**FINAL DRAINAGE REPORT
FOR
HOMESTEAD NORTH AT STERLING RANCH FILING NO. 3**

**August 2022
Project No. 25188.12**

**PCD Filing No.:
SF-22-XX**

Swale A-A

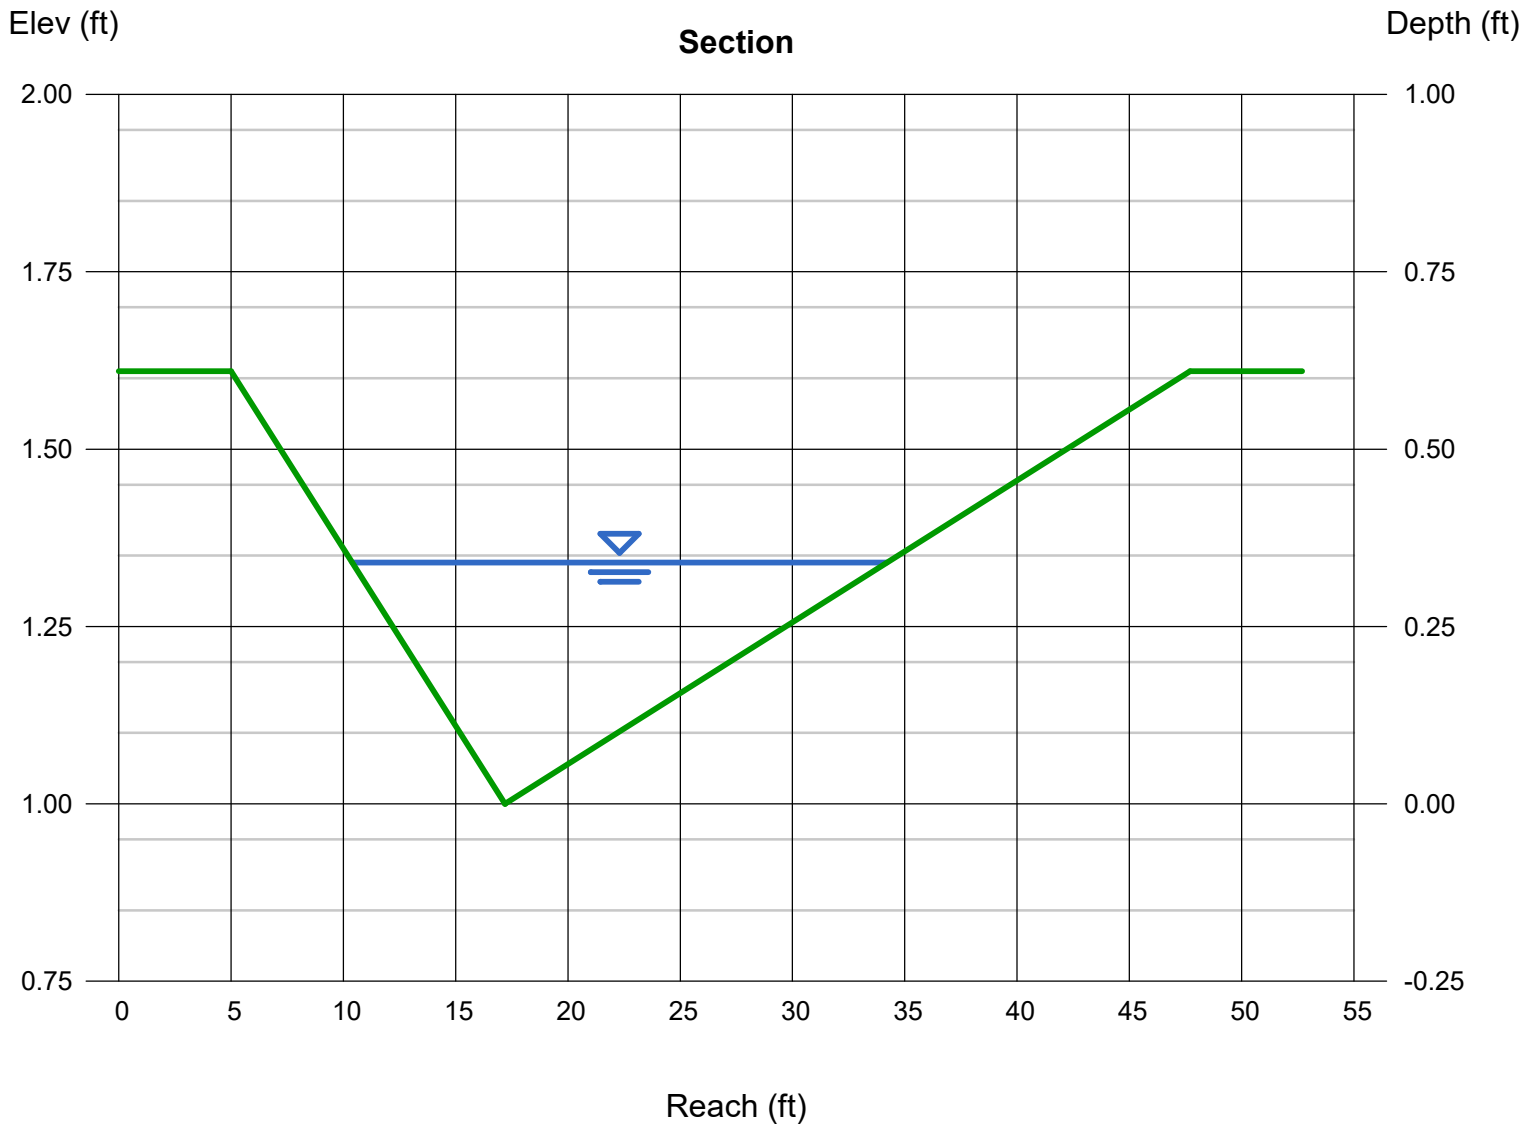
This sheet appears to be a duplicate. Please delete.

Pond A - Spillway RipRap

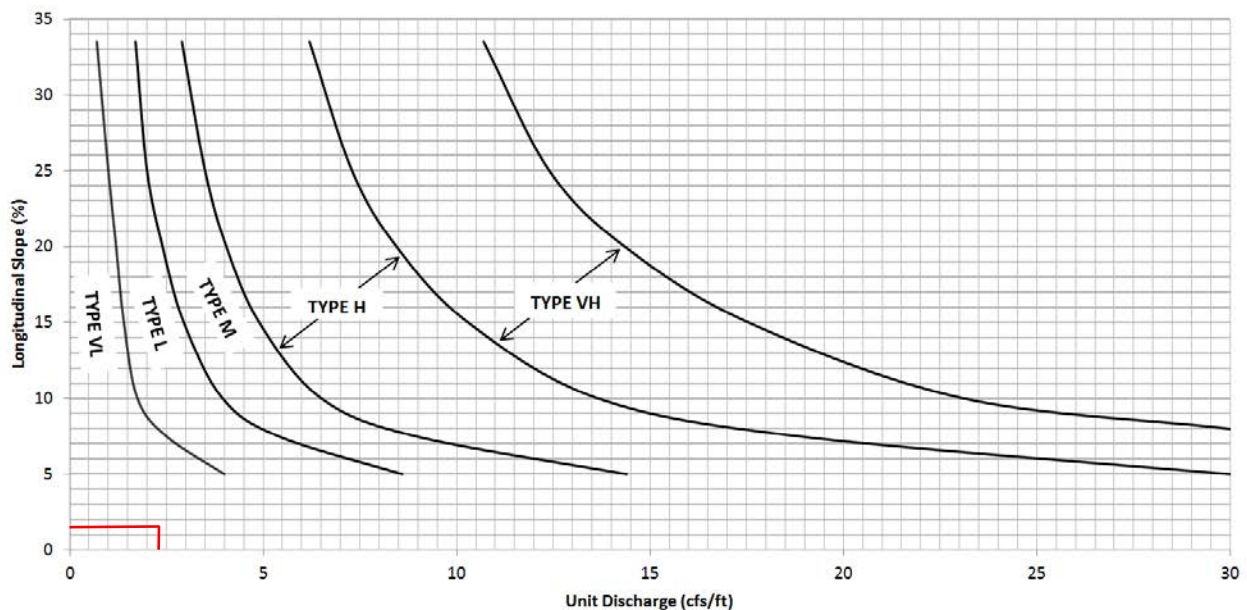
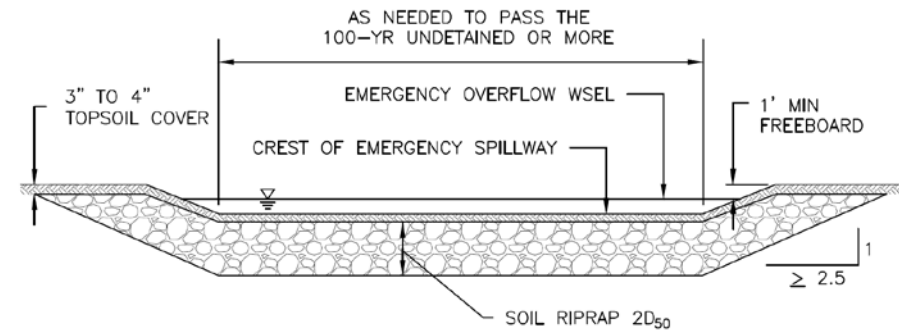
Include design of trickle channel

PROPOSED CONDITIONS DRAINAGE MAP
HOMESTEAD NORTH AT STERLING RANCH FILING NO. 3
JOB NO. 25188.10
08-02-2022
SHEET 1 OF 1

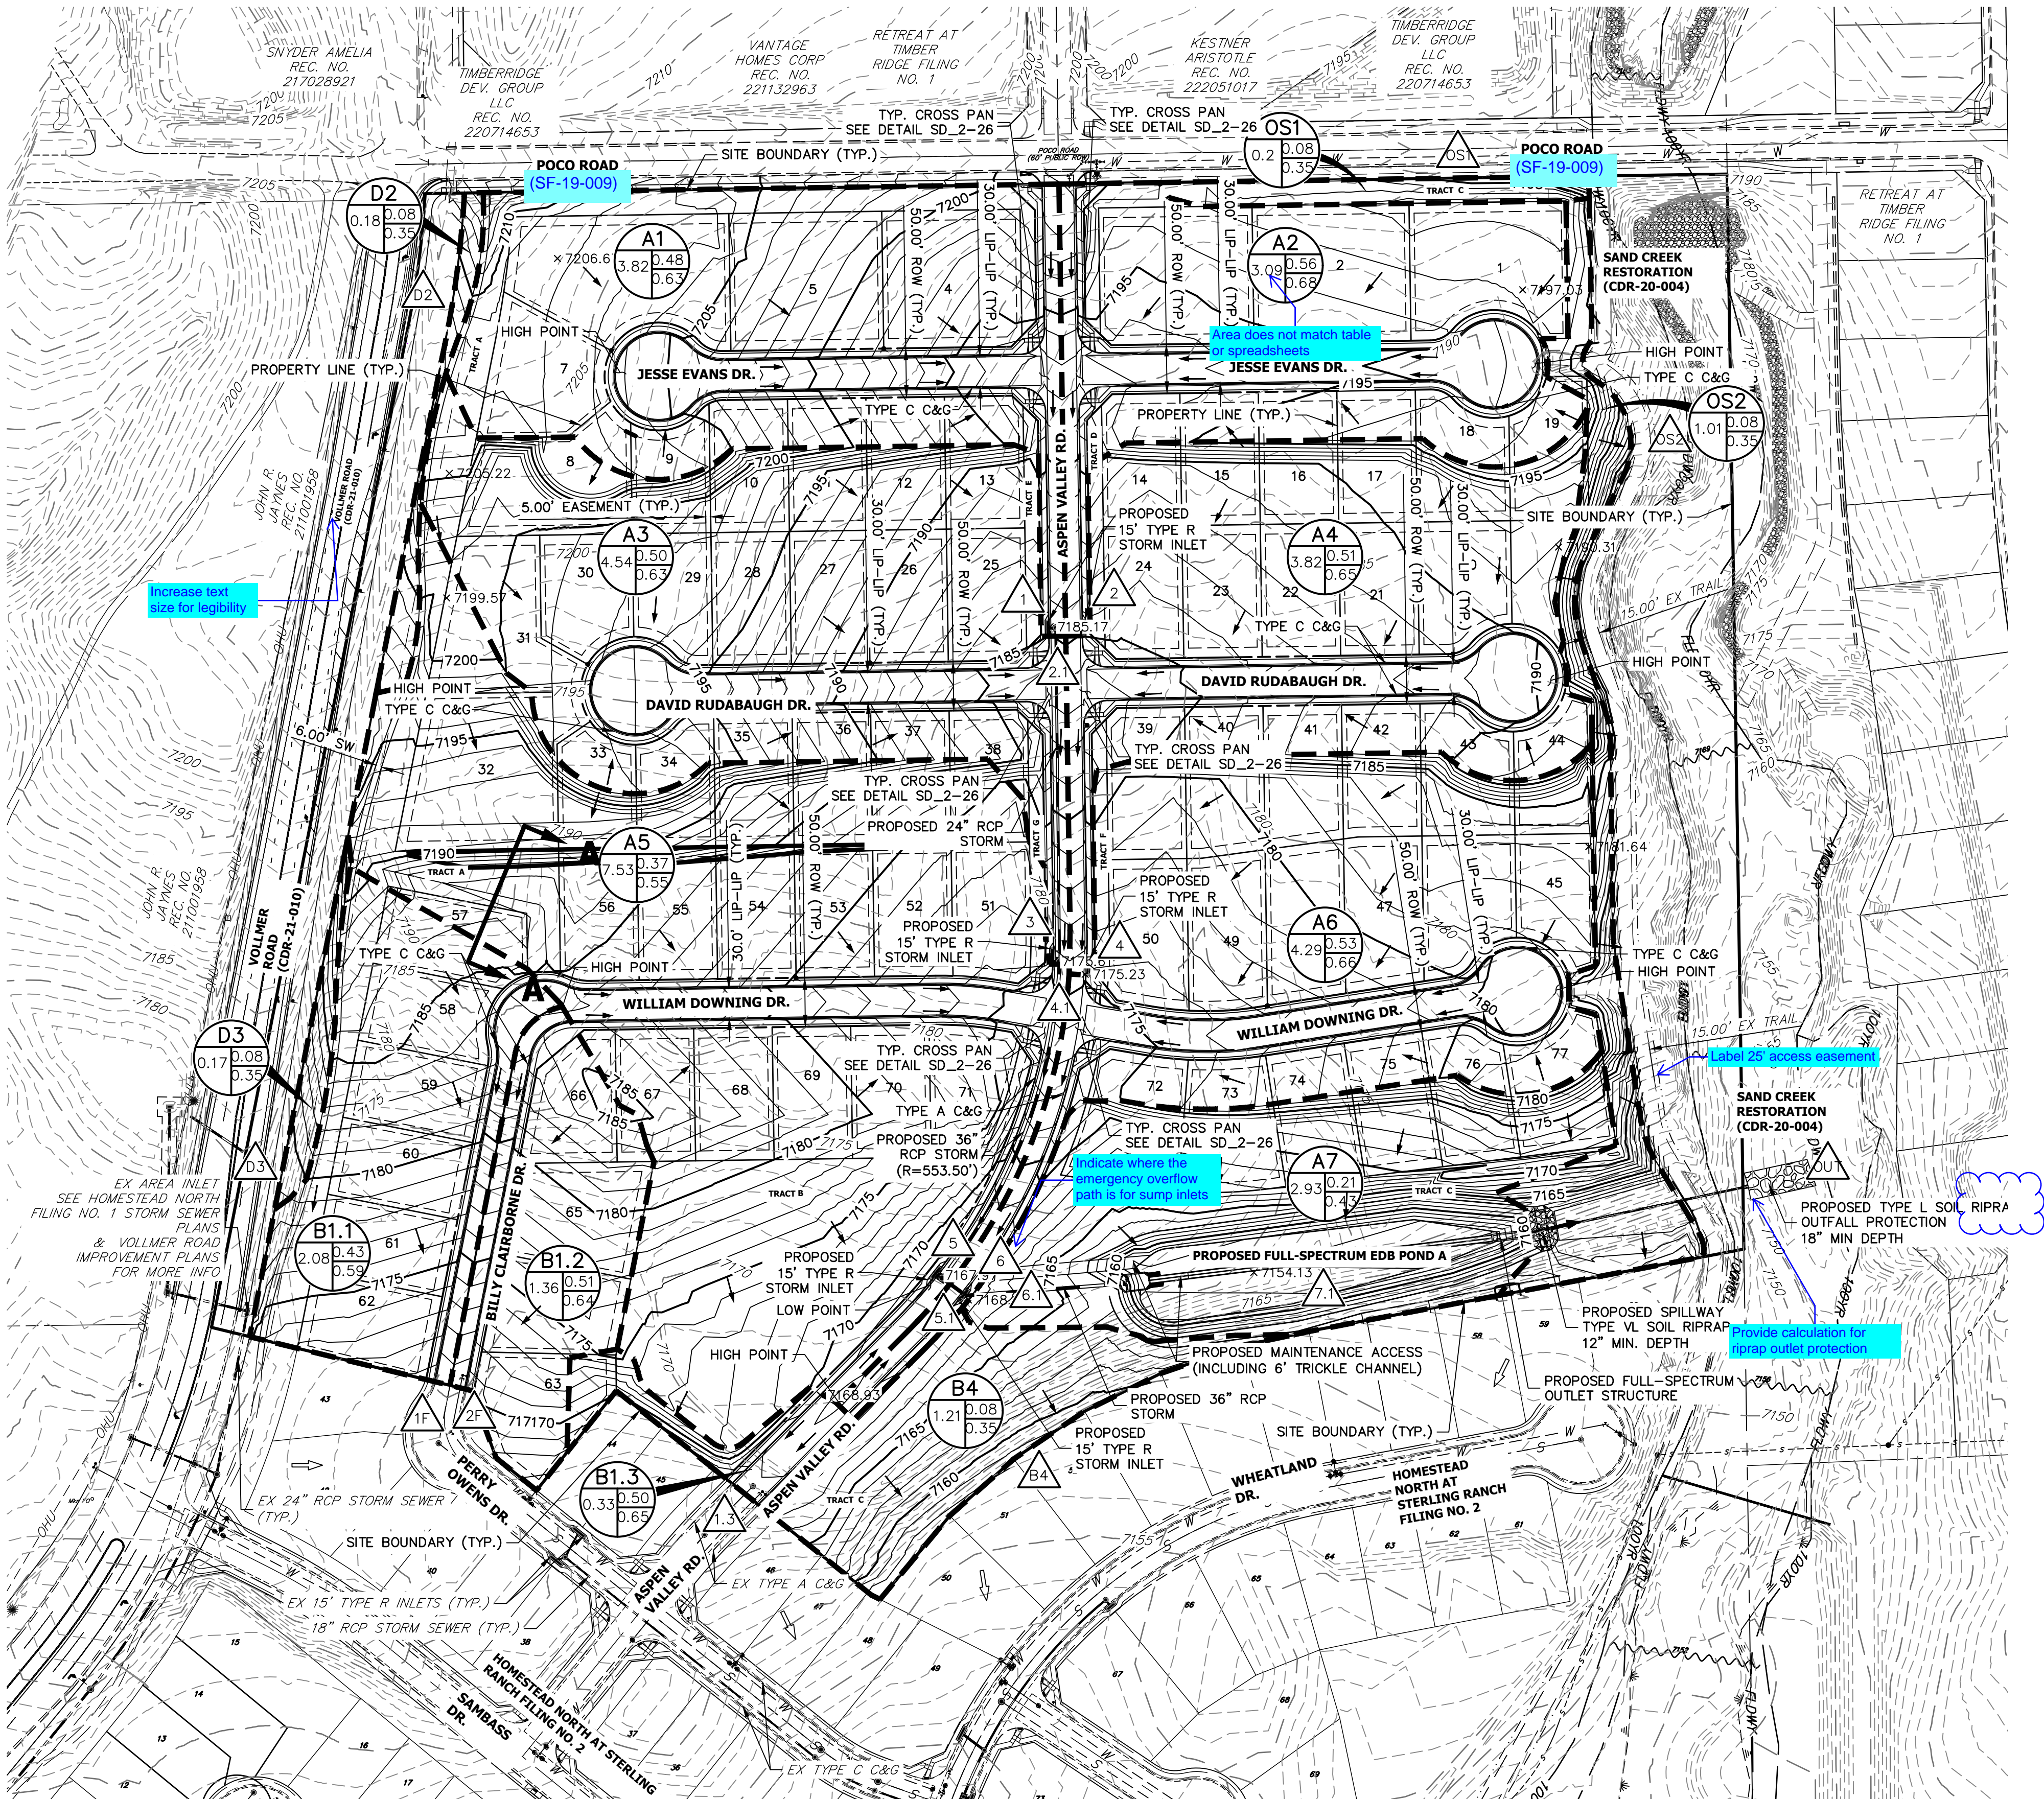
Add proposed items to legend
